SCOTTISH HOSPITALS INQUIRY

**Bundle of document for Oral hearings
commencing from 13 May 2025 in relation
to the Queen Elizabeth University Hospital
and the Royal Hospital for Children,
Glasgow**

**Miscellaneous Drawings – Drawings and
Room Data Sheets**

Drawing Title
FOURTH FLOOR PLAN
RENAL WARD / WARD CASE WARD (2 of 2)
CEILING FINISHES - STRATEGY PLAN

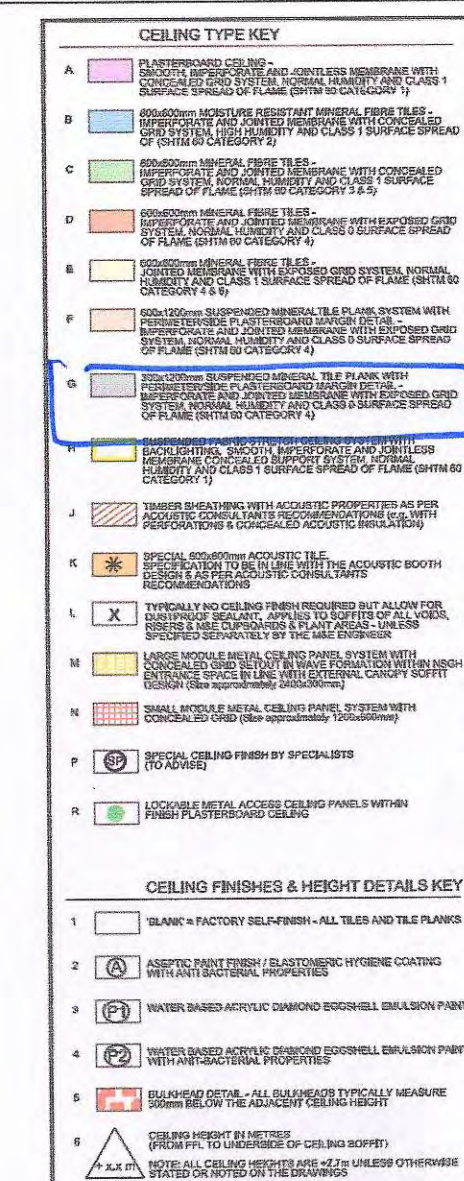
NOTE
ALL TYPE G TO
BE REPLACED
WITH TYPE F

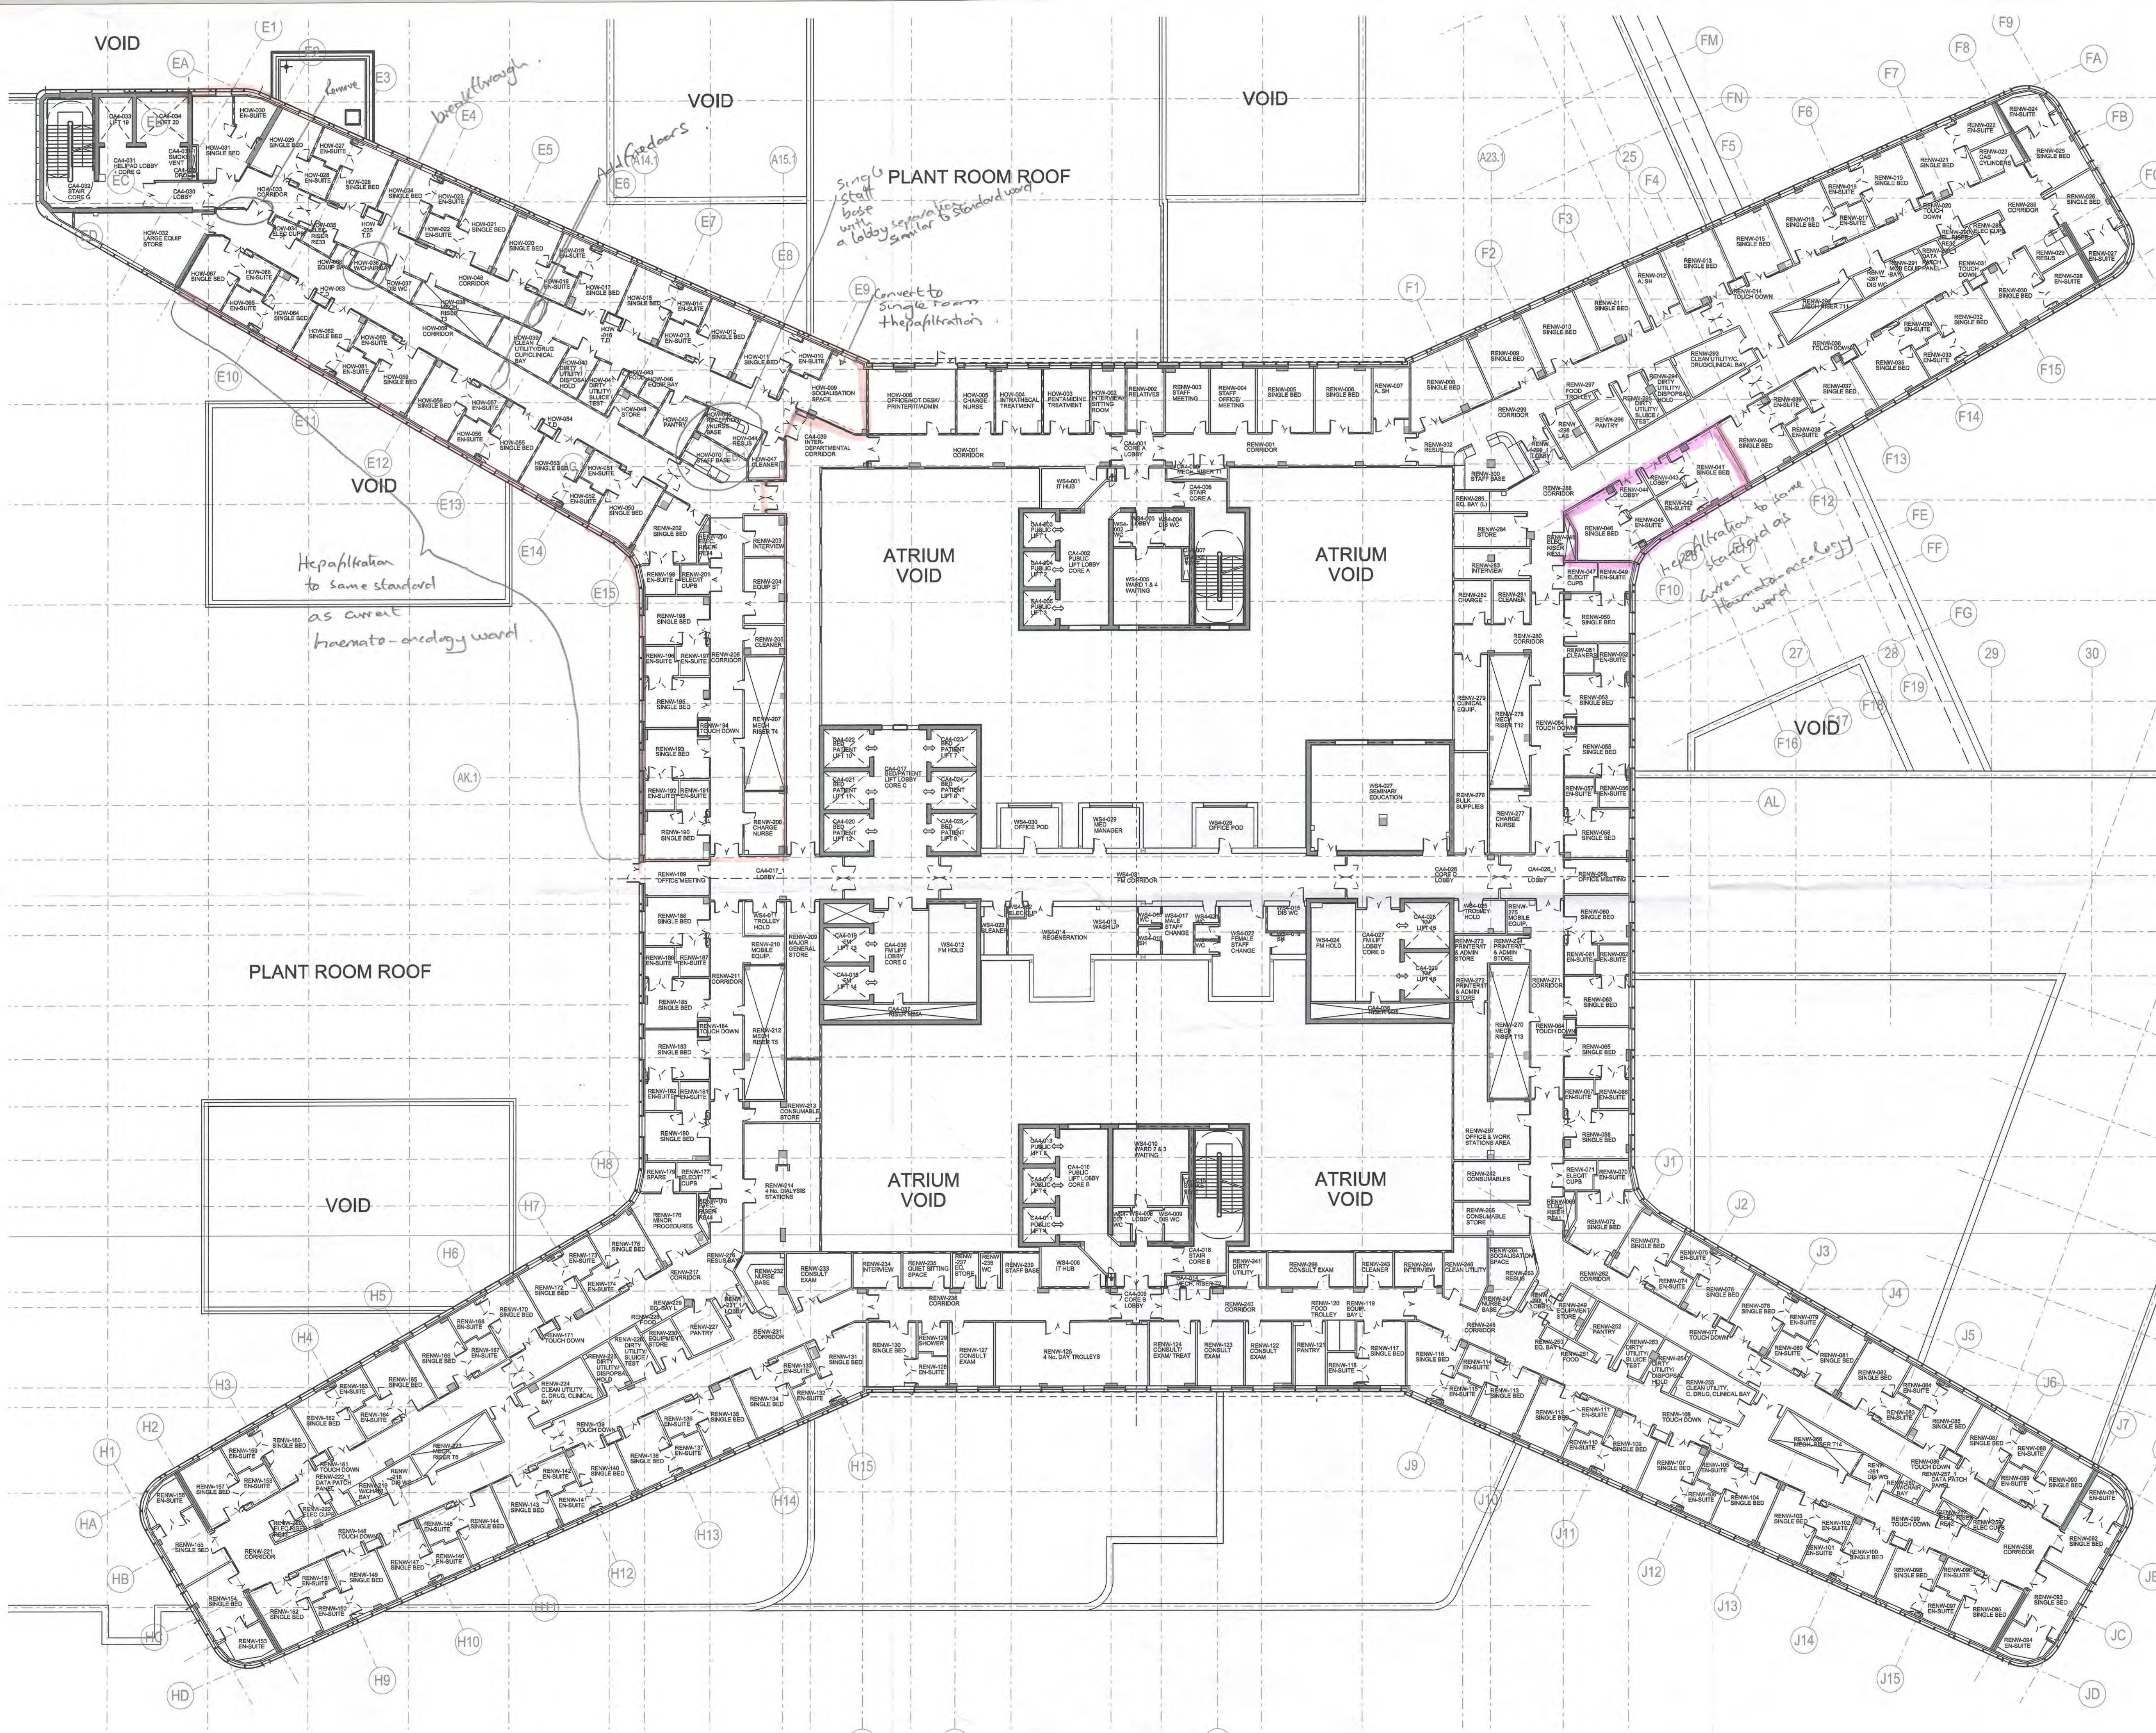
- all rooms denoted * hepa-filtrated
- ward cross over at mid point as agreed
- door to end of ward retained
- mid ward corridor doors already included
- additional glazed screen as requested
- extended nurse station desk as requested
- cleaners room incorporate in lieu of equipment bay
- office reduced to 5pax

IN ORIGINAL PLANS
Rooms
RENW 190
RENW 193
RENW 195
RENW 198
RENW 202
ARE PLUMBED FOR
DIALYSIS — THIS
IS TO REMAIN
Including
media panels

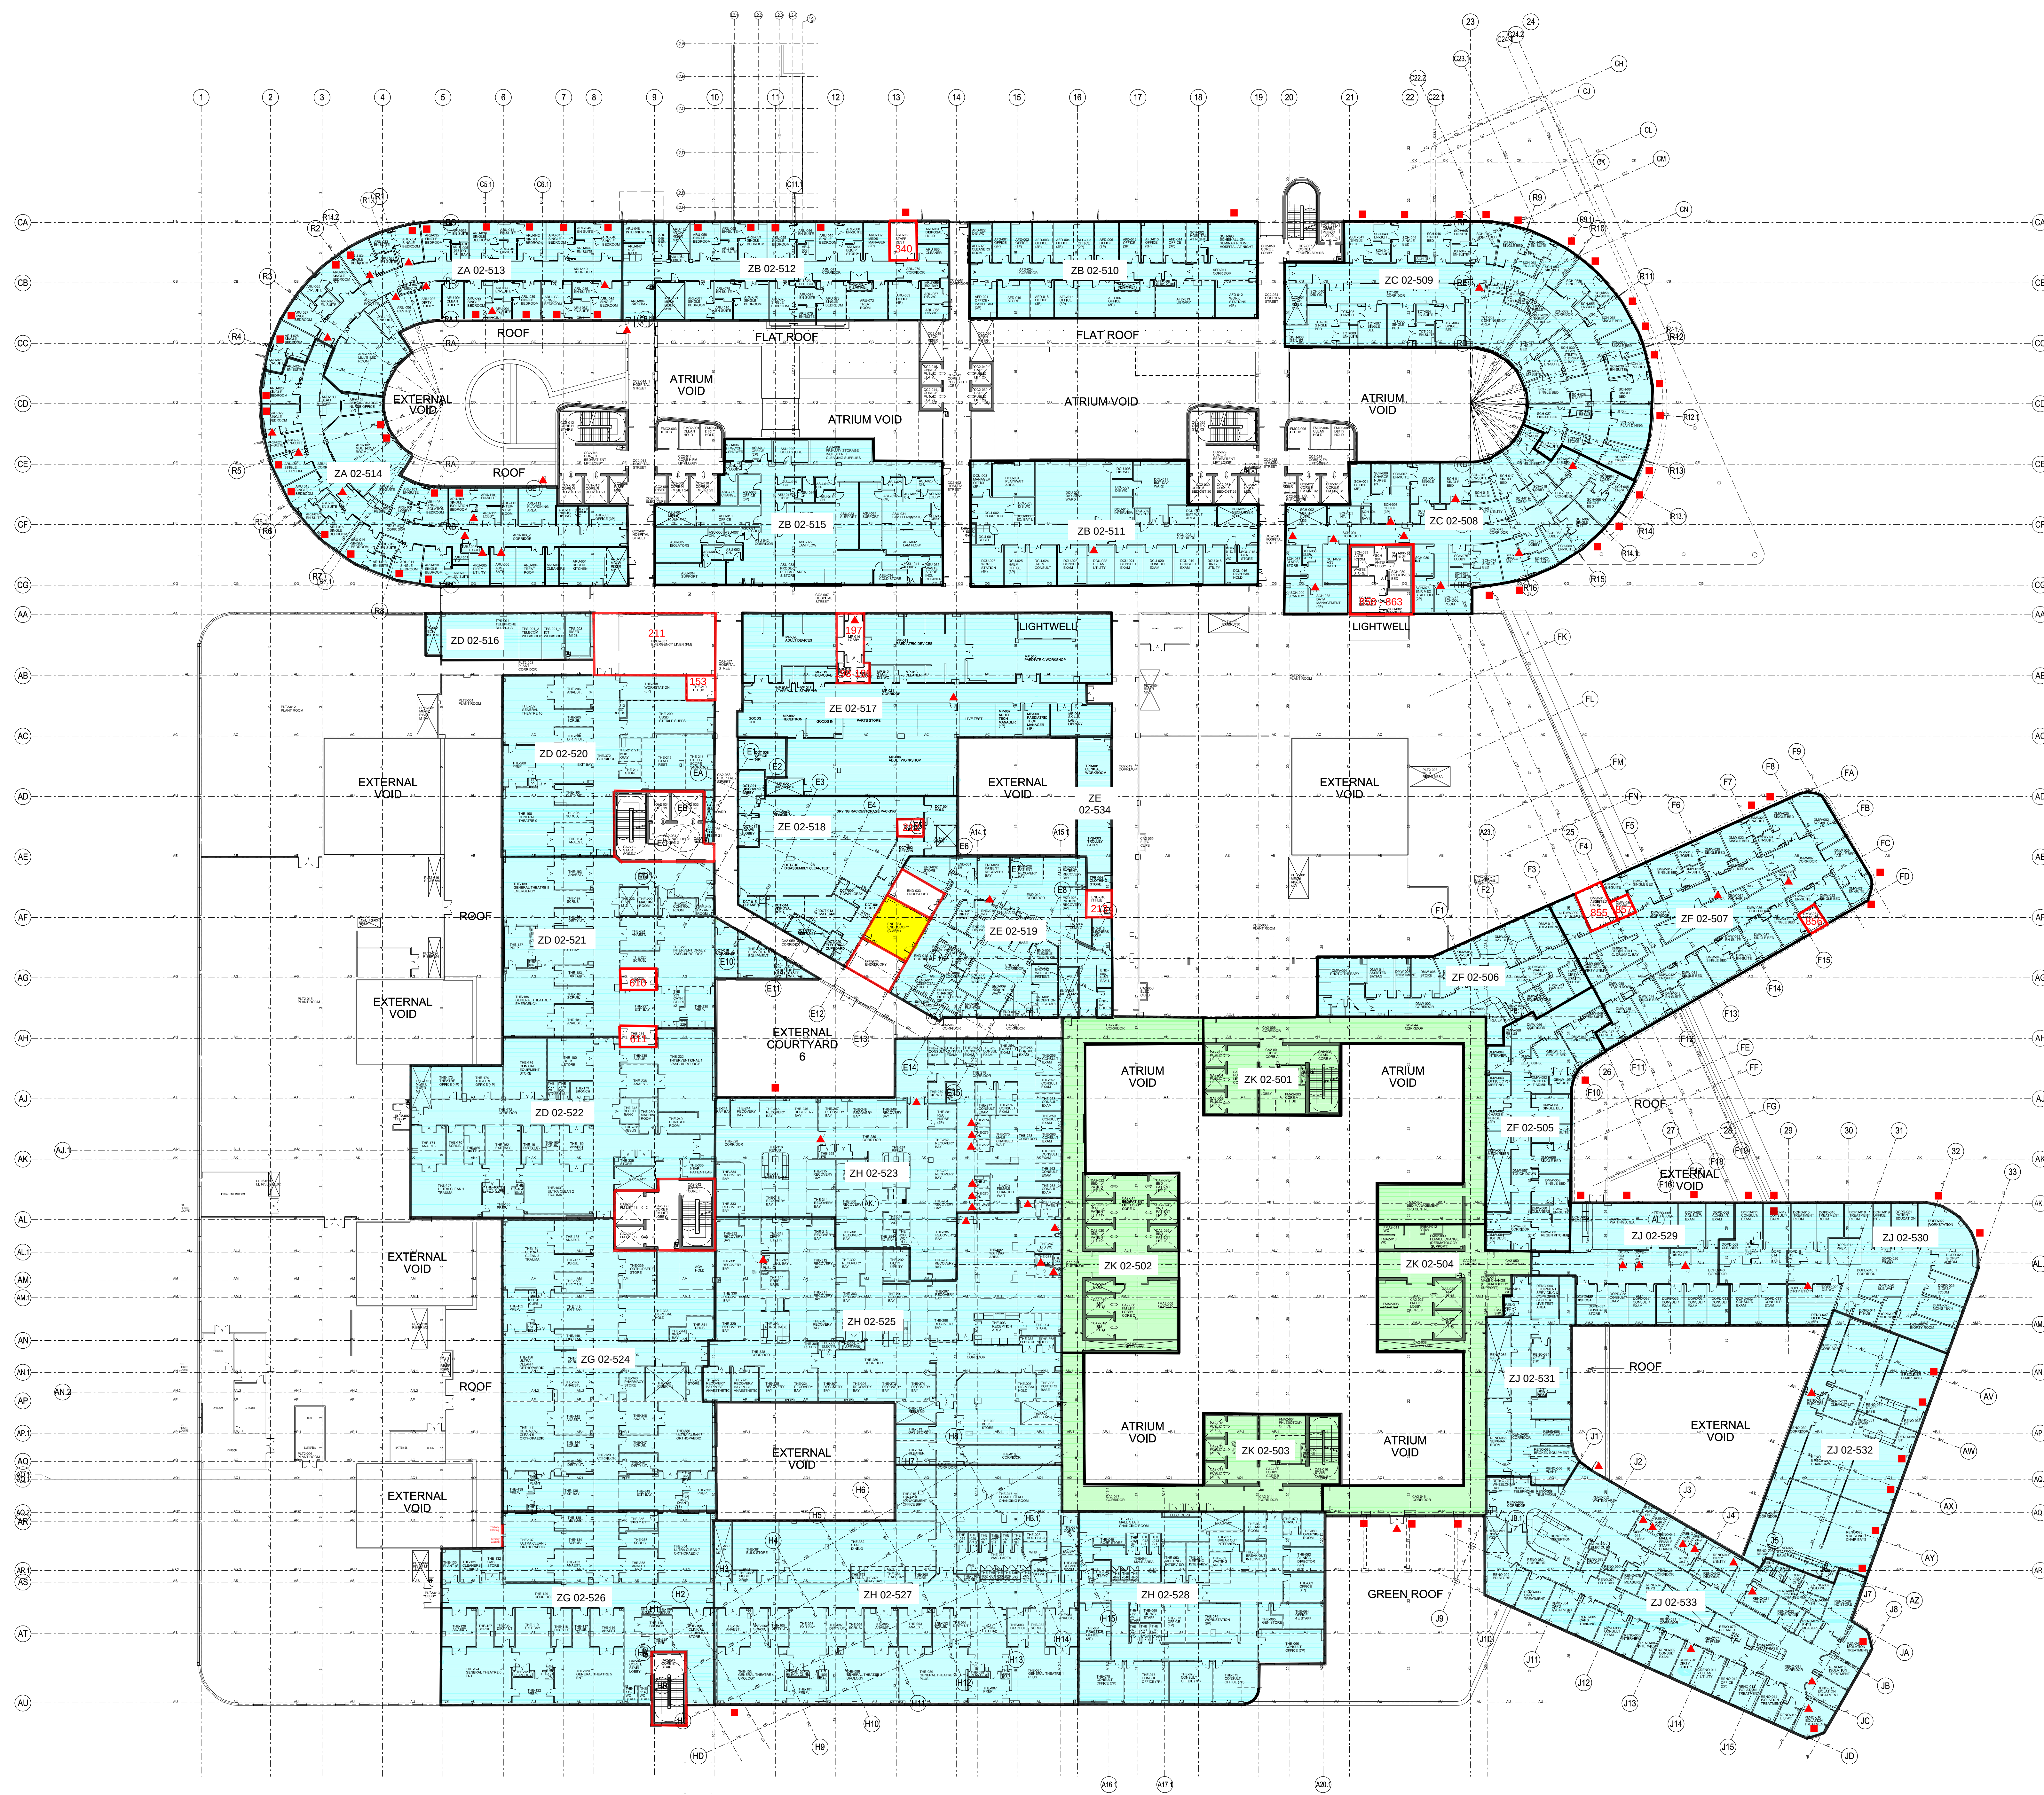
Equipment Bay replaced with cleaners room
